Grounds for appeal/Background
Email from the case officer on 11 Jan 2023.
Hi Abdul,
Thanks for sending me the amended plans.

I therefore request the appeal inspector to take this into consideration and allow our appeal based on the latest amended drawings (E) .Drawings attached.

PROJECT PROPOSED EXTENSIONS & LOFT CONVERSION INCLUDING DORMERS	REVISIONS			SITE 123 Charville Lane Hayes UB4 8PD	PROJECT NO: PL/04		SHEET TITLE PROPOSED DRAWINGS		CLIENT Mr. Habib		Drawing produced by AWarchitecture Contact: 07934 906060 awarchitecture@yahoo.co.uk
	A	12/01/2024	AW		SCALE as shown @A3	DATE 06/08/2023	DEALT AW	CHECKED AW			
	B	13/01/2024	AW								
	C	24/01/2024	AW								
	D	24/01/2024	AW								
	E	24/01/2024	AW								
	F	24/01/2024	AW								
	G	24/01/2024	AW								
	H	24/01/2024	AW								
	I	24/01/2024	AW								
	J	24/01/2024	AW								
	K	24/01/2024	AW								
	L	24/01/2024	AW								
	M	24/01/2024	AW								
	N	24/01/2024	AW								
	O	24/01/2024	AW								
	P	24/01/2024	AW								
	Q	24/01/2024	AW								
	R	24/01/2024	AW								
	S	24/01/2024	AW								
	T	24/01/2024	AW								
	U	24/01/2024	AW								
	V	24/01/2024	AW								
	W	24/01/2024	AW								
	X	24/01/2024	AW

PROPOSED ROOF PLAN
1:100 @A3

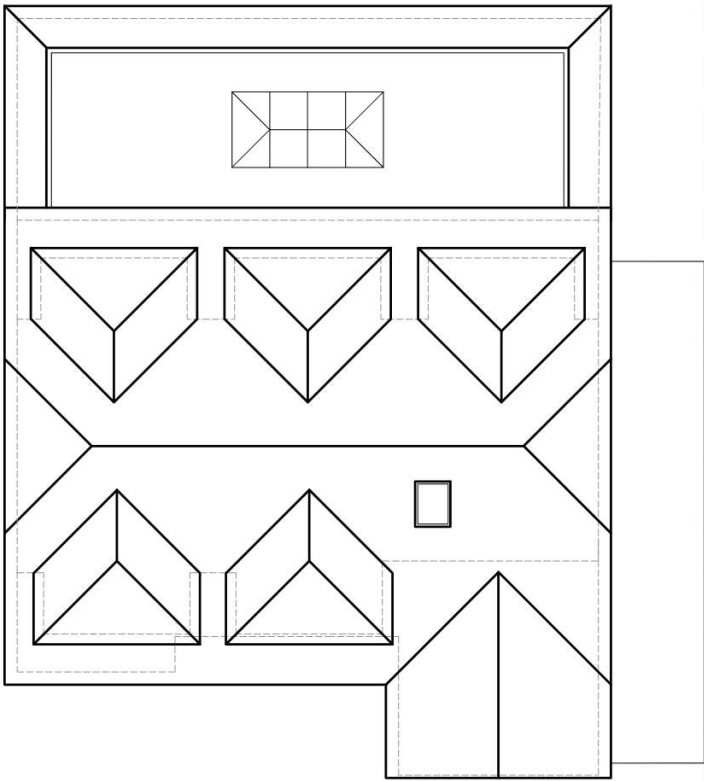
As submitted we will be refusing the amended scheme for similar reasons.
All dormers should be reduced in size and you should perhaps consider removing some eaves.
DMHD 1 states - roof extensions should be located on the rear elevation only, be subservient to the scale of the existing roof and should not exceed more than two thirds the average width of the original roof. They should be located below the ridge tiles of the existing roof and retain a substantial element of the original roof slope above the eaves line;

We are happy to accept front dormers in this location because of site context and other properties, however everything is too big.

As per the case officer's request I sent him amended drawings and the amendment being (E) as given in the attached drawings.
However the application was not decided based on the revised(E) drawings emailed on 12/01/2024.

In my opinion the revised drawings are proportional in terms of scale and appearance. Hence they should overcome the case officer's concerns.
